Architect's Supplemental Instructions

Architect's ASI No: 041

Project:
Webster University
Interdisciplinary Science
Building

Date Issued: 12/13/2016

4 SECURE DOOR - DOUBLE
SCALE: NONE

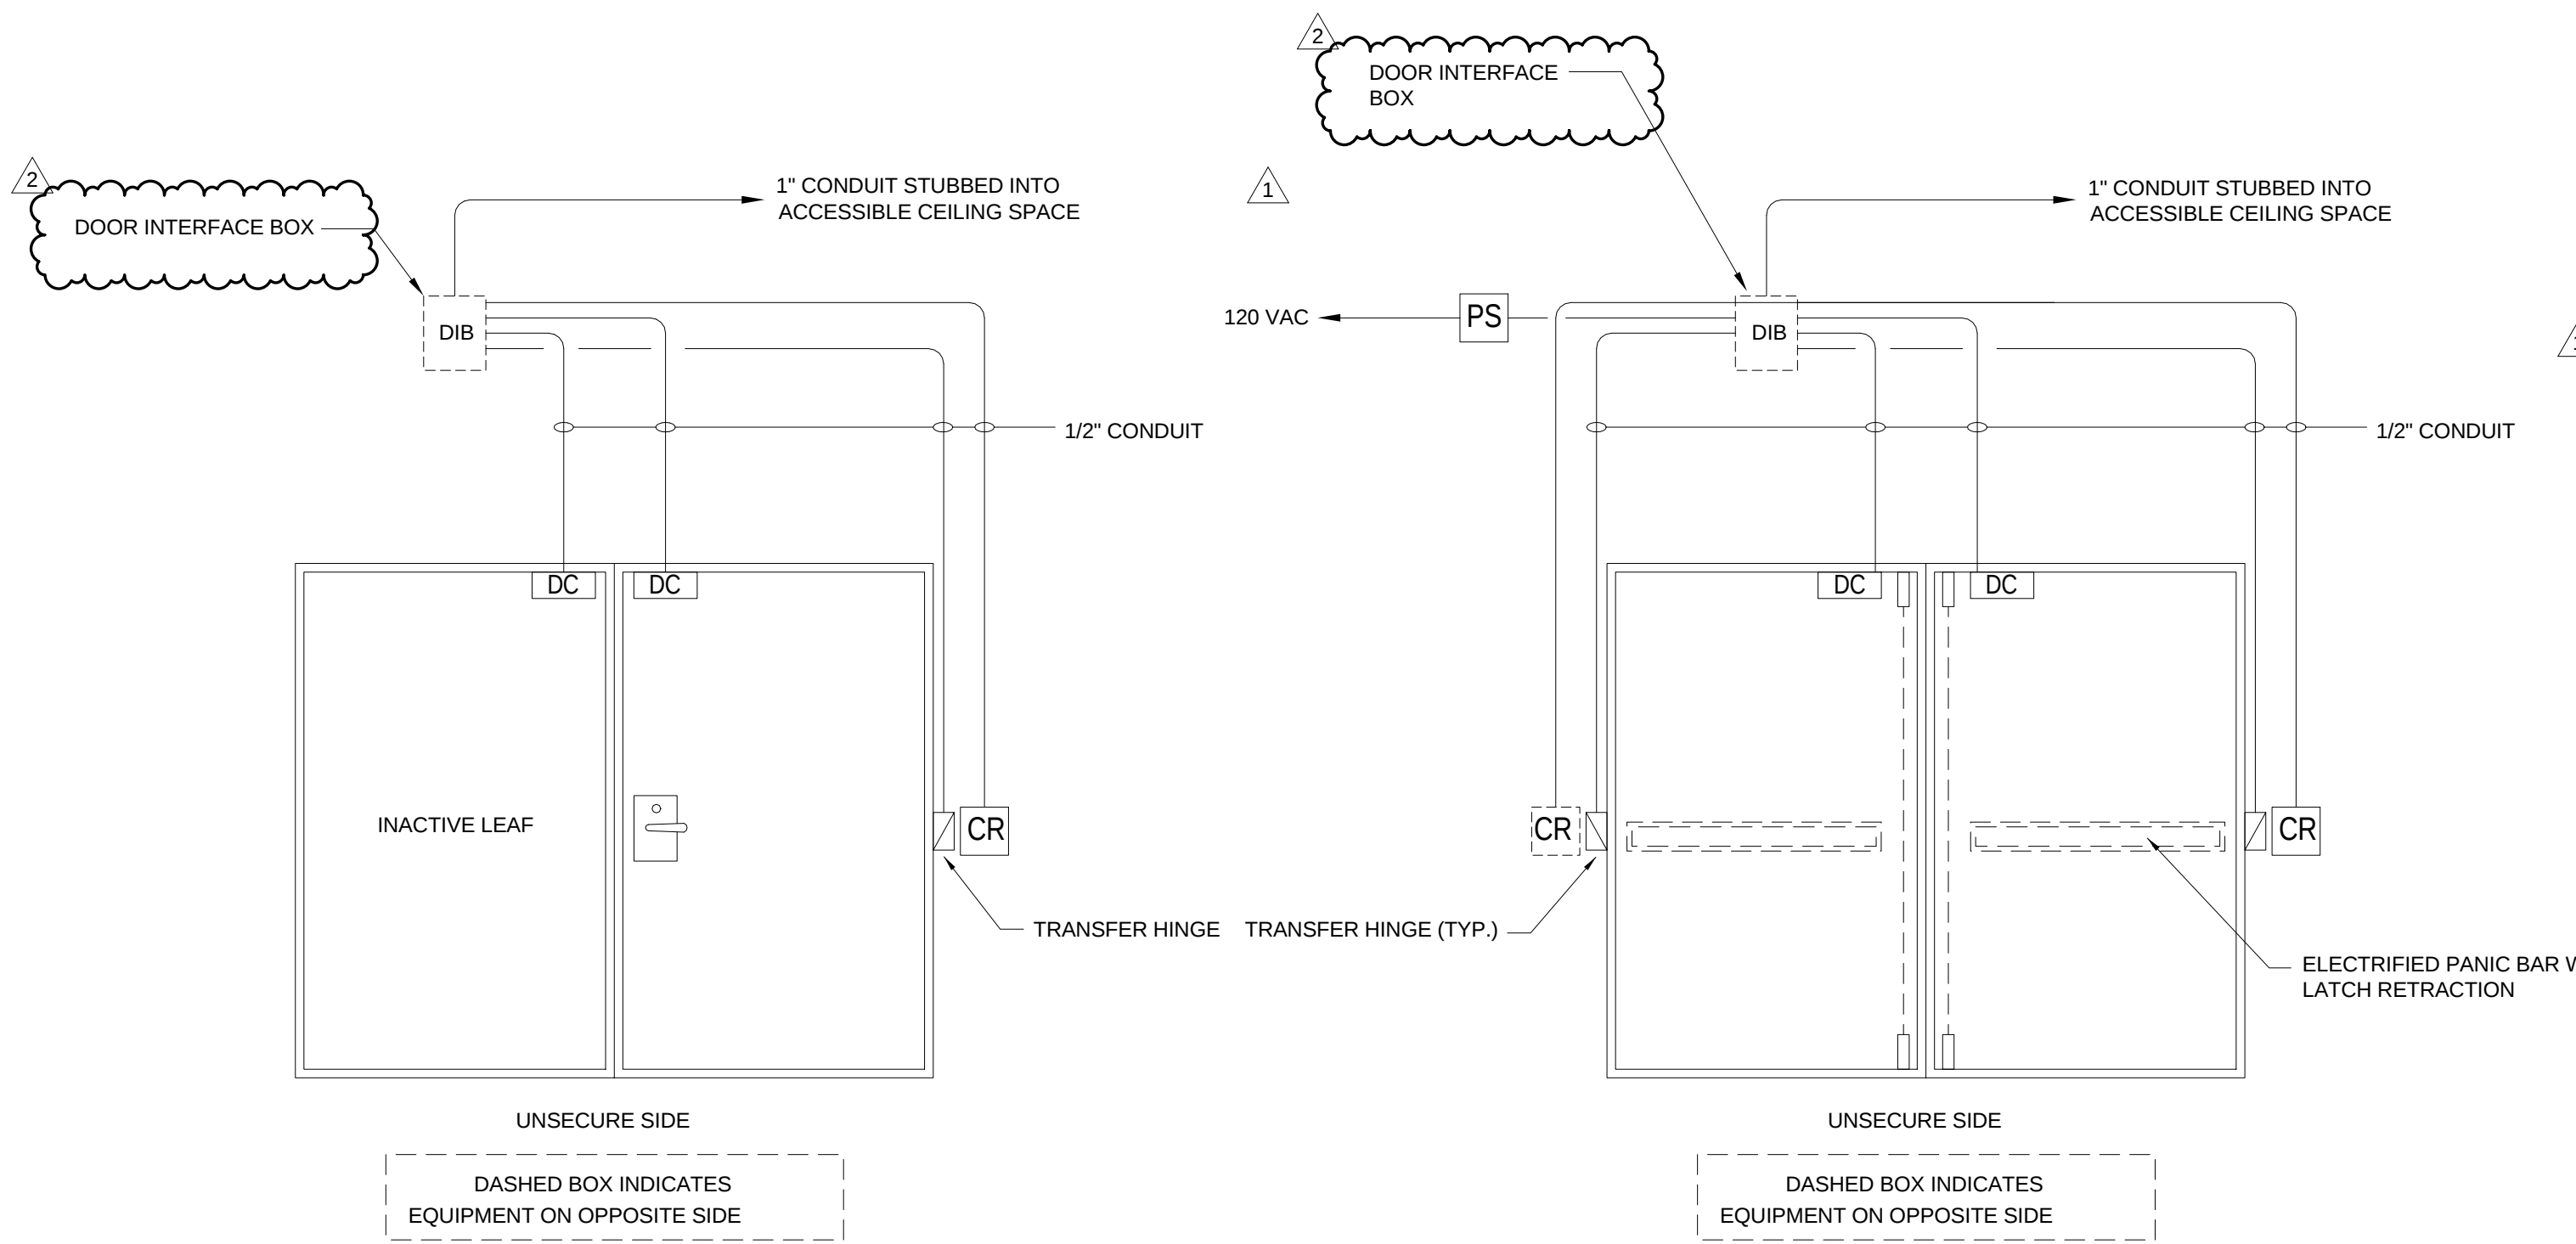
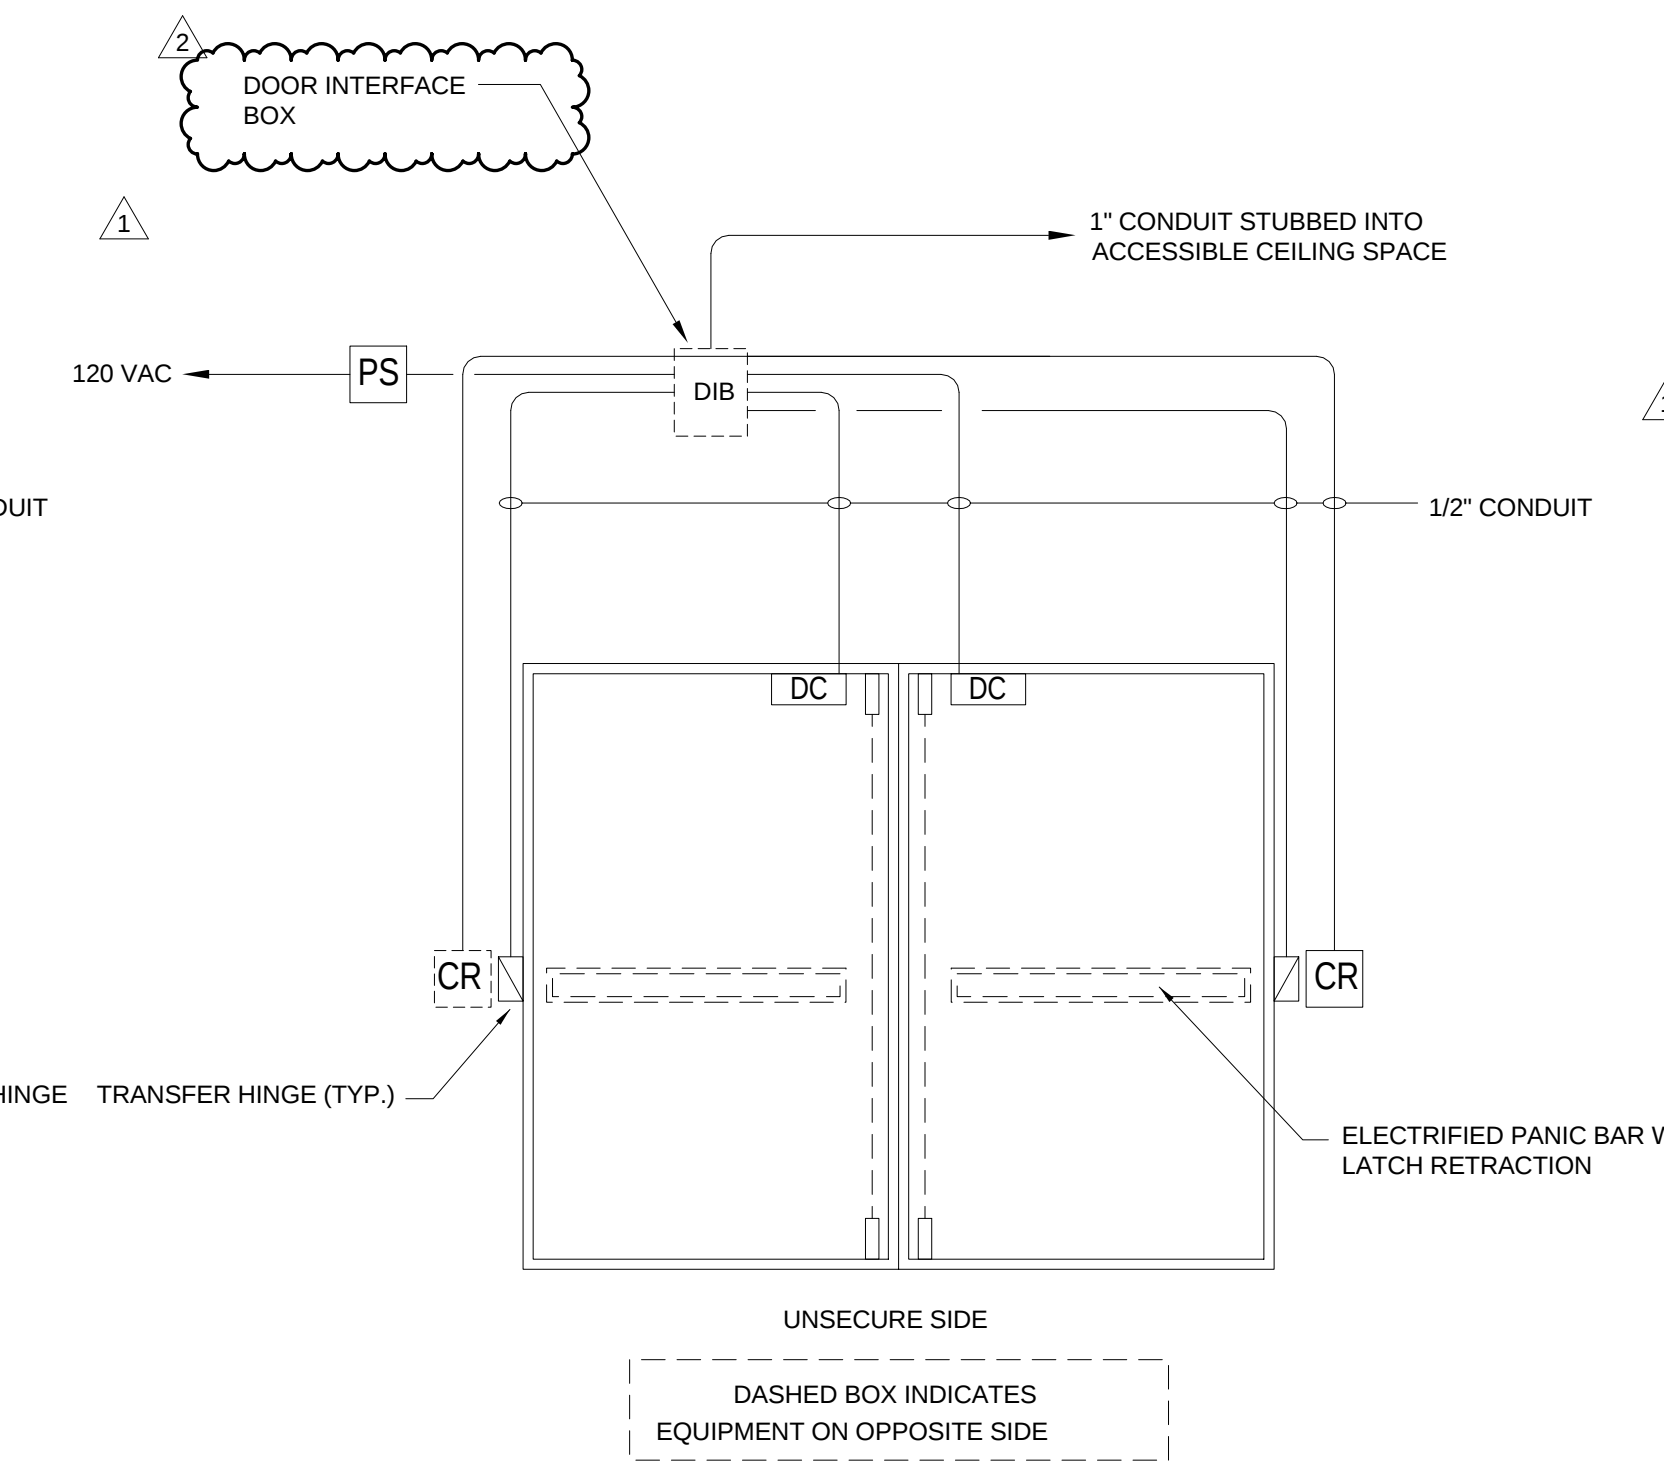
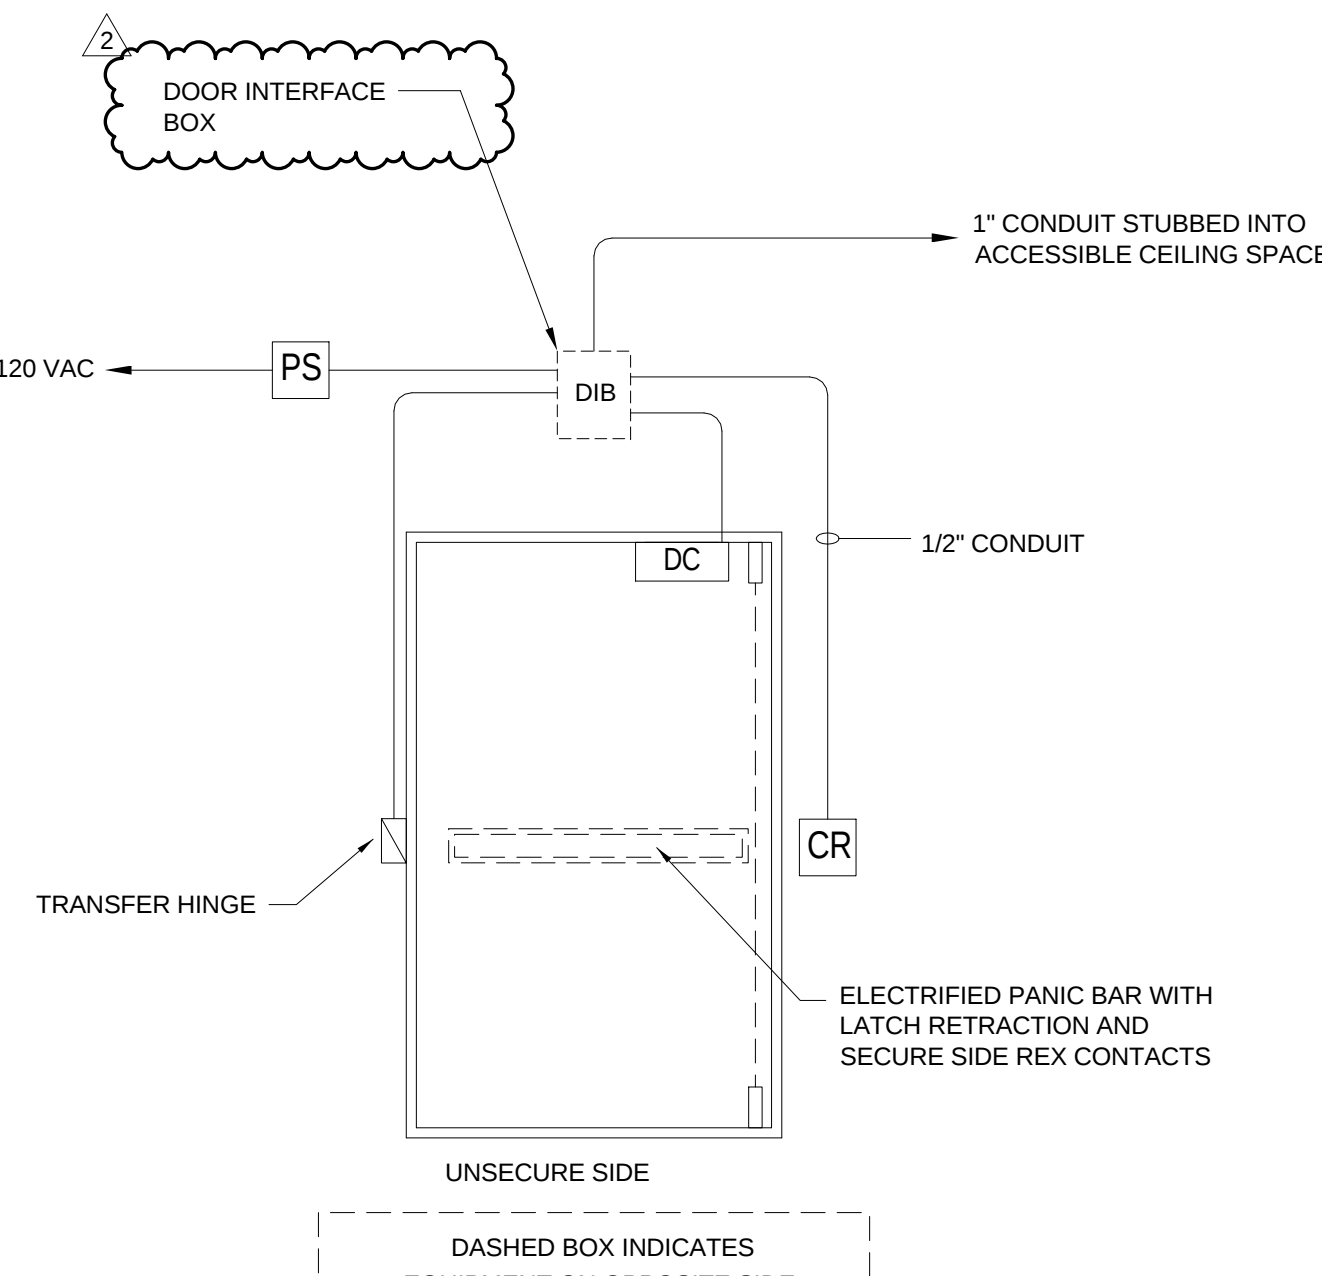
1. T0101.A – LEVEL 01 FLOOR PLAN – AREA B
 - A. Relocated access control equipment from door 170 to door 150.
2. T0803 – ACCESS CONTROL BLOCK DIAGRAMS
 - A. Revised Level 1 block diagram
3. T0804 – ACCESS CONTROL DETAILS
 - A. Revised Door Interface Boxes
 - B. Revised Access Control System cable
 - C. Revised General Notes
 - D. Revised Responsibility matrix
